**SUNDRY NOTICES AND REPORTS ON WELLS**  
*Do not use this form for proposals to drill or to re-enter an abandoned well. Use form 3160-3 (APD) for such proposals.*

8. Well Name and No.  
ORRTANNA 20 FED 705H

EOG Resources requests an amendment to our approved APD for this well to reflect a change to a 4-string casing design as attached.

Proposed Wellbore  
Revised 4/16/18  
API: 30-025-43745

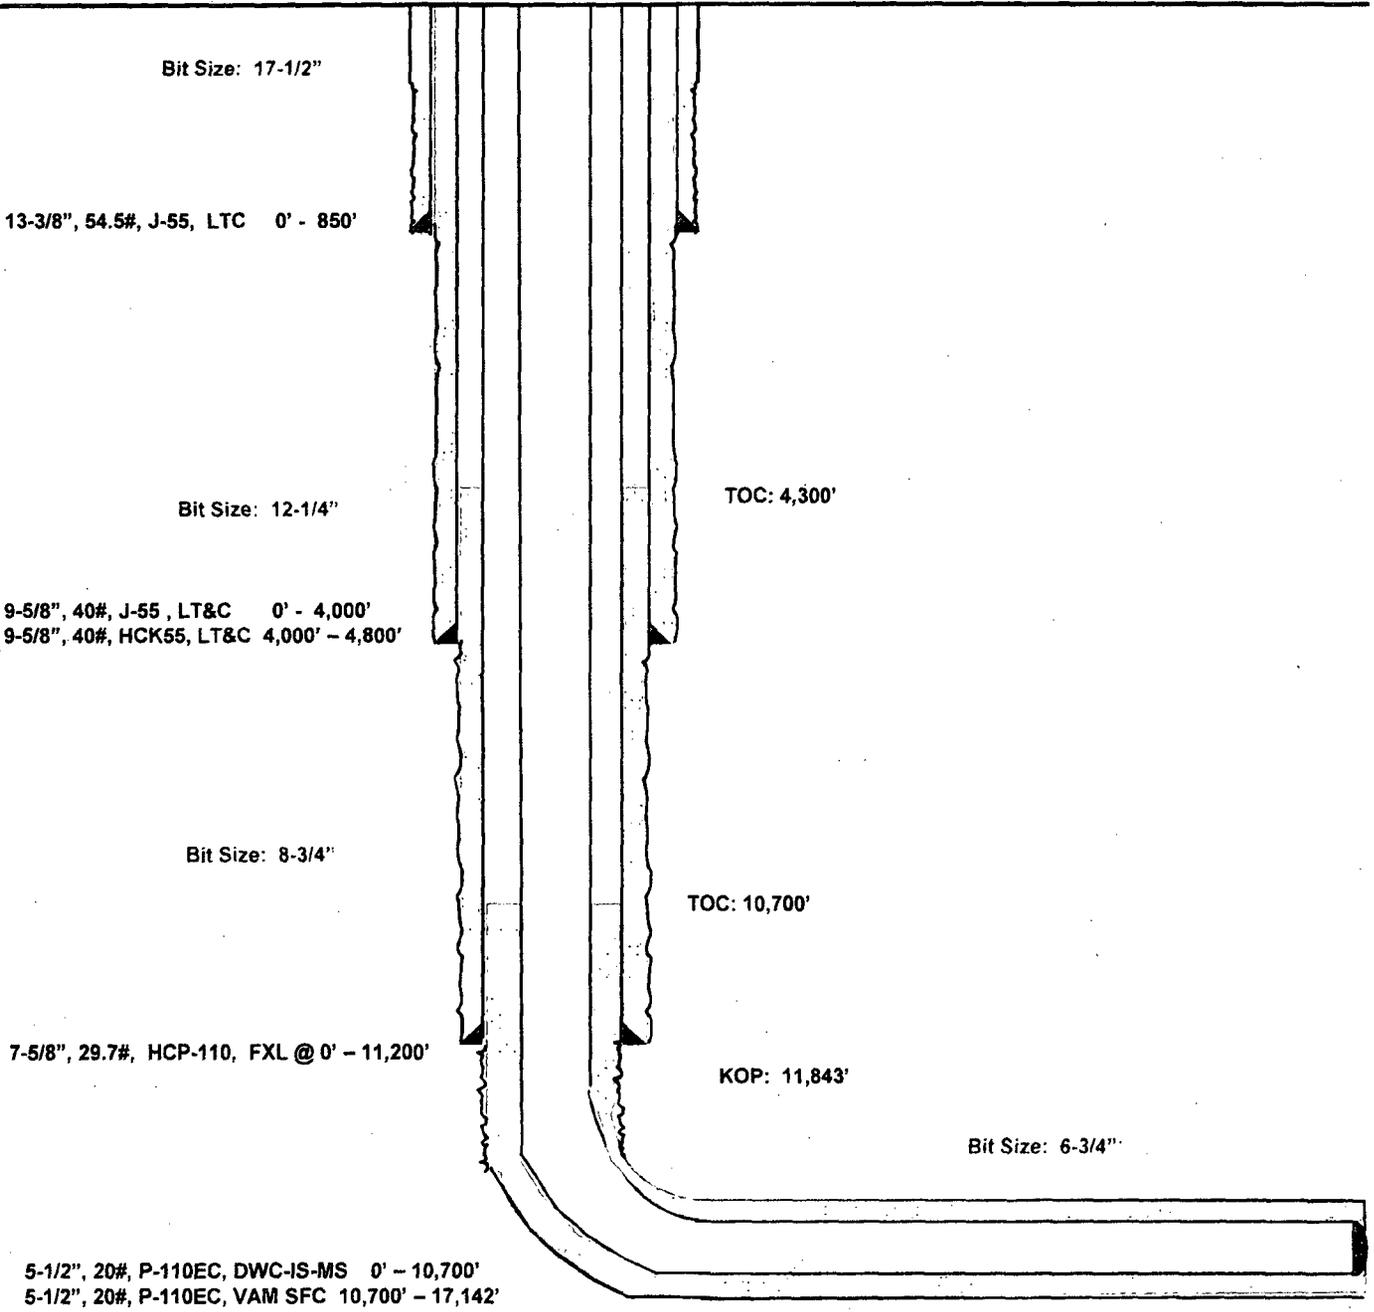
Variance is requested for annular clearance of the 5-1/2" x 7-5/8" to the top of cement.

Hole Size	Interval	Csg OD	Weight	Grade	Conn	DF <sub>min</sub> Collapse	DF <sub>min</sub> Burst	DF <sub>min</sub> Tension
17.5"	0 - 850'	13.375"	54.5#	J55	STC	1.125	1.25	1.60
12.25"	0-4,000'	9.625"	40#	J55	LTC	1.125	1.25	1.60
12.25"	4,000' - 4,800'	9.625"	40#	HCK55	LTC	1.125	1.25	1.60
8.75"	0 - 11,200'	7.625"	29.7#	HCP110	FXL	1.125	1.25	1.60
6.75"	0 - 10,700'	5.5"	20#	P110EC	DWC CIS MS	1.125	1.25	1.60
6.75"	10700-17142'	5.5"	20#	P110EC	VAM SFC	1.125	1.25	1.60
